Ravine Improvements

Re: Deering Oaks Pond Bottom Replacement – Ravine Improvements
Request for Plan Revision for Project 2014-096 Level 1 Site Alteration Approval

**DEERING OAKS RAVINE
SCHEMATIC PLANTING PLAN
CITY OF PORTLAND, MAINE**

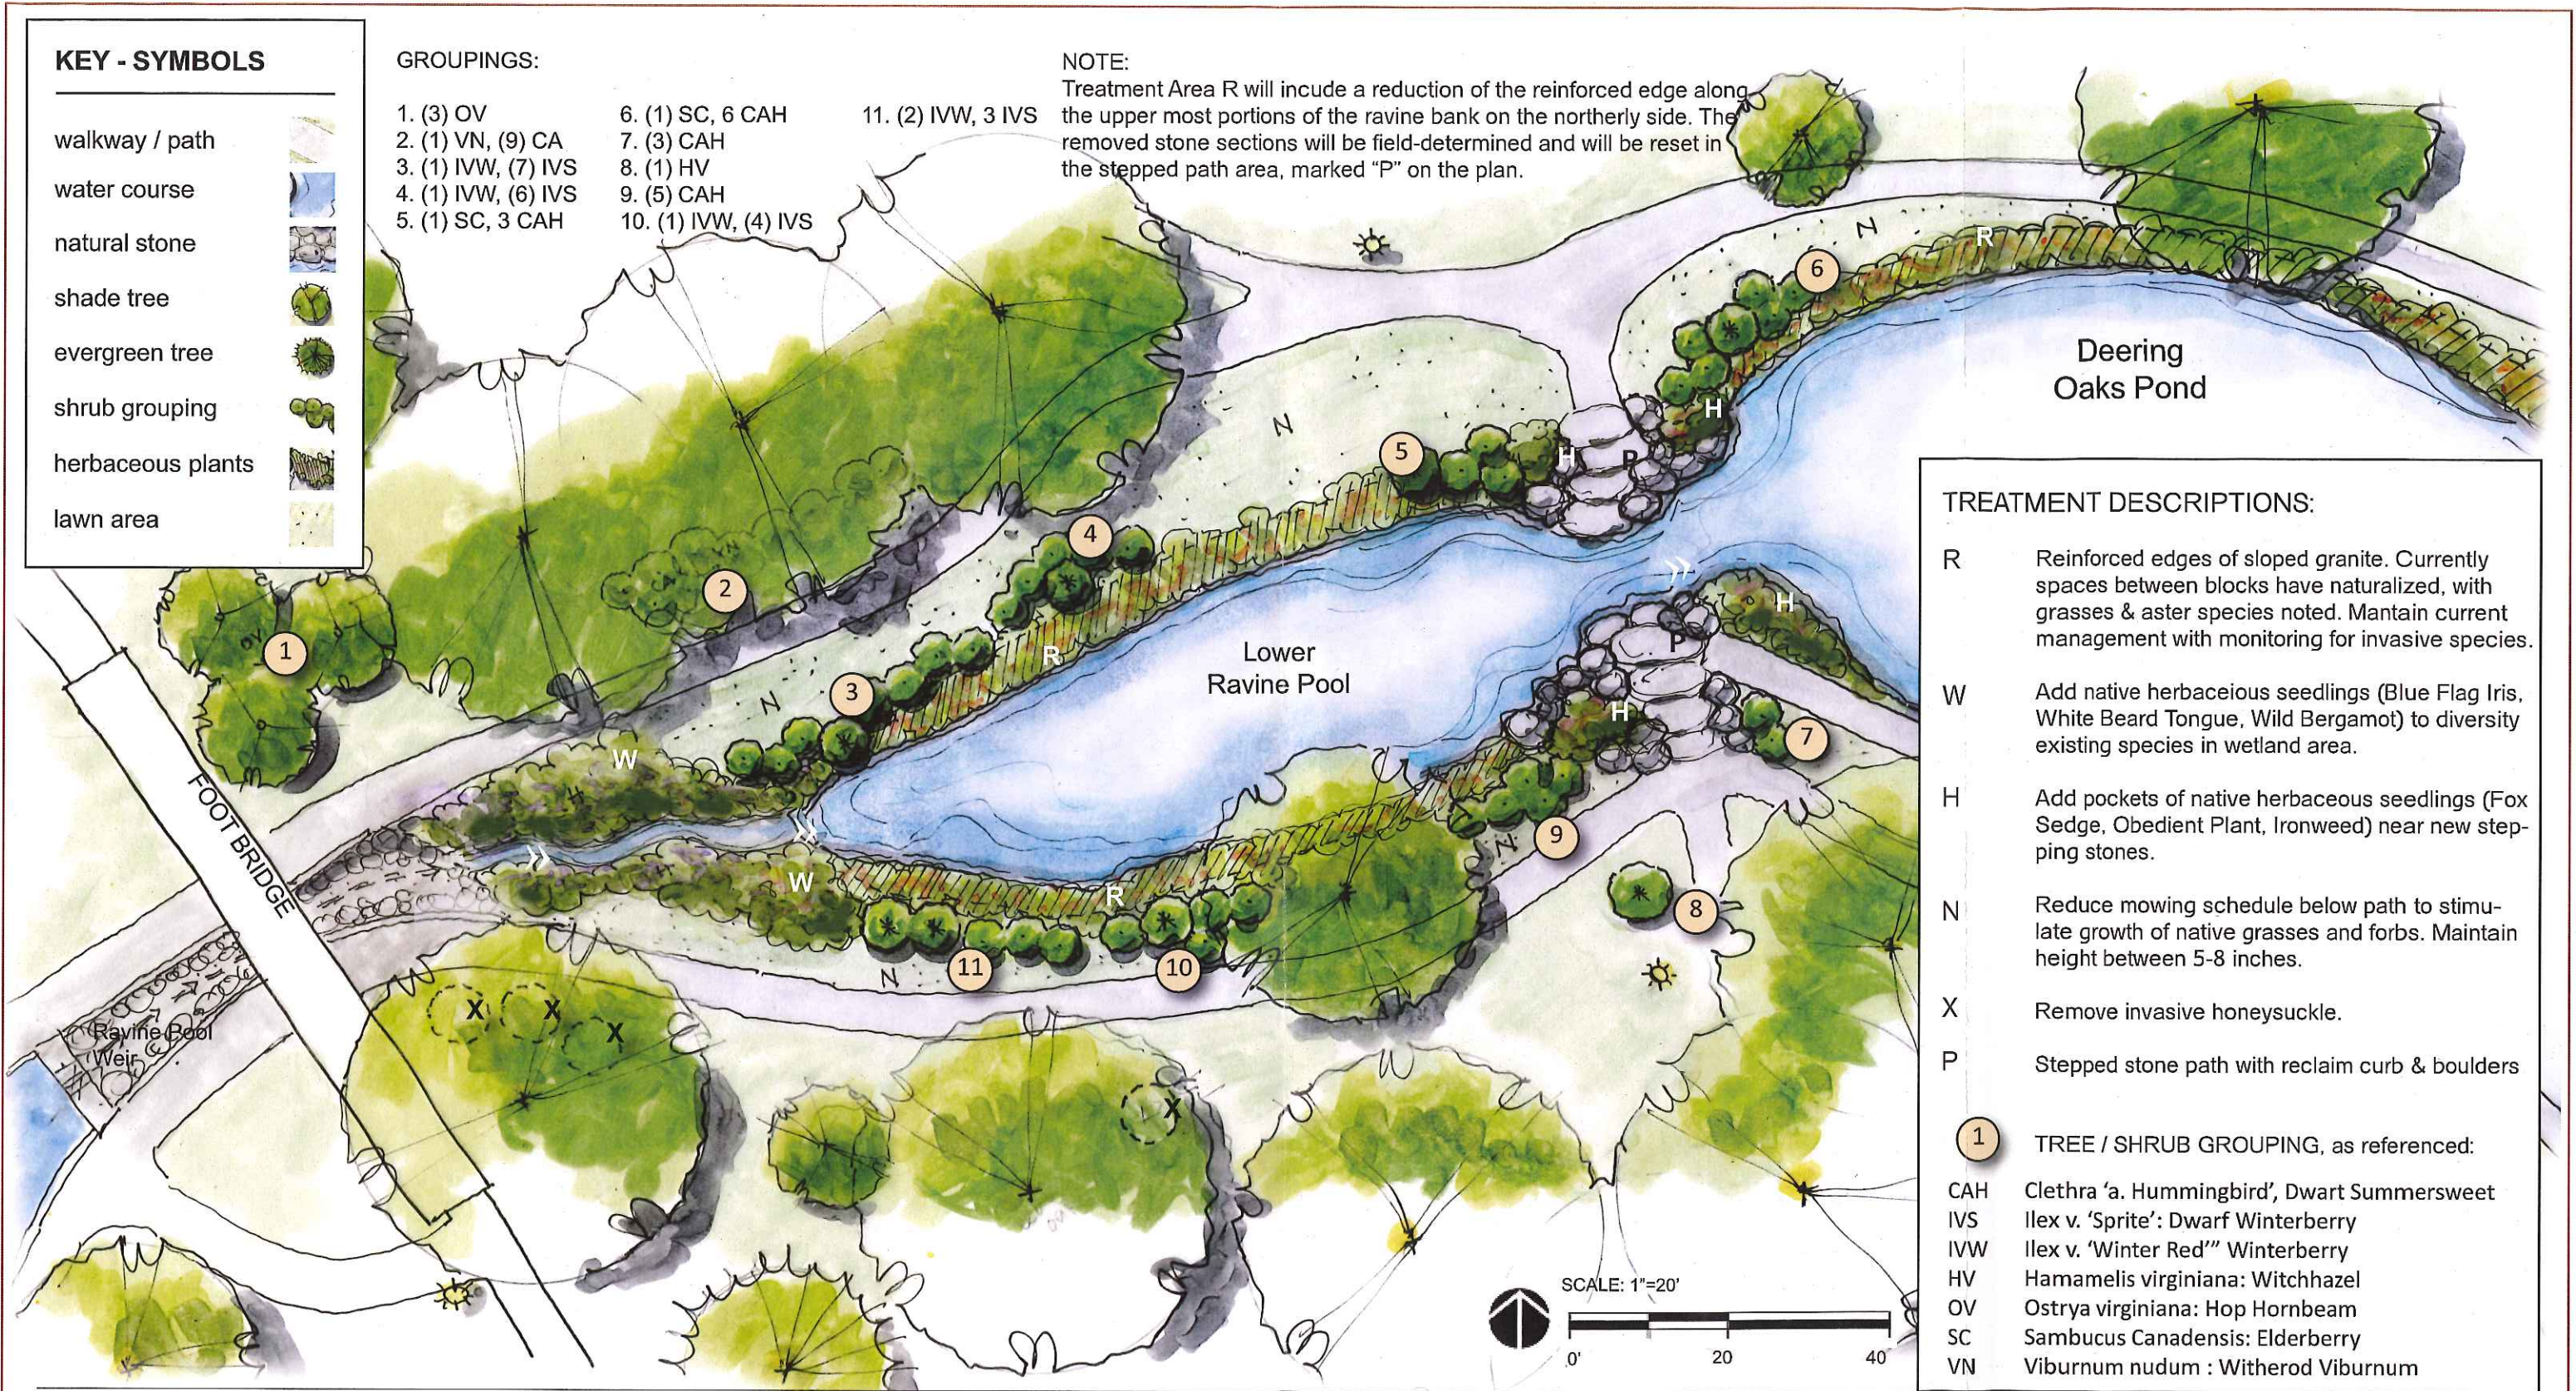
As a result of public comments on the Deering Oaks Pond Bottom Replacement project, the City of Portland's Transportation, Sustainability, & Energy (TSE) Committee requested that the design team pursue improvements to the ravine area of Deering Oaks Pond. The goal was to increase buffer vegetation along the ravine and help stabilize the inslopes of the ravine. In response to the TSE concerns, work proposed in this area will include new plantings, invasive species control and naturalization as shown in detail on the enclosed Schematic Planting Plan.

The proposed plan for lower ravine includes native understory trees, shrubs to stabilize steep banks and herbaceous plants to enhance visual interest and diversity of species in the wetland areas. The reinforced edges of sloped granite will be retained and seeded-in native plants, including grasses and several species of aster, will be nurtured in the spaces between the blocks. The wetland soils just east of the foot bridge will be enhanced with flowering herbaceous plants, such as Blue Flag Iris White Beard Tongue and Wild Bergamot. Colonizing and wettolerant native shrubs, including Winterberry, Summersweet and Elderberry are proposed in groupings along the stabilized bank edge, with Summerweet and Witherod Viburnum proposed in swaths along the northern upland, where the slope is very steep. Hophornbeam trees and Witchhazel plantings supplement the understory in this area.

There are limited improvements proposed beyond plantings. The plan also calls for improving access to the wetland at the former pedestrian bridge location via stepped reclaim curbing bordered by boulders. These stones will be hand selected for rounded edges and will have similar qualities to those in the Ravine Pool Area. At the request of staff, a portion of the reinforced granite edge will be removed and utilized in this area. The stepped feature will allow visitors to explore plantings along the ravine edge while reducing unwanted impacts to planted areas..

Treatment Area R will include a reduction of the reinforced edge along the upper most portions of the ravine bank on the northerly side. The removed stone sections will be field-determined and will be reset in the stepped path area, marked "P" on the plan.

- R** Reinforced edges of sloped granite. Currently spaces between blocks have naturalized, with grasses & aster species noted. Maintain current management with monitoring for invasive species.
- W** Add native herbaceous seedlings (Blue Flag Iris, White Beard Tongue, Wild Bergamot) to diversity existing species in wetland area.
- H** Add pockets of native herbaceous seedlings (Fox Sedge, Obedient Plant, Ironweed) near new stepping stones.
- N** Reduce mowing schedule below path to stimulate growth of native grasses and forbs. Maintain height between 5-8 inches.
- X** Remove invasive honeysuckle.
- P** Stepped stone path with reclaim curb & boulders
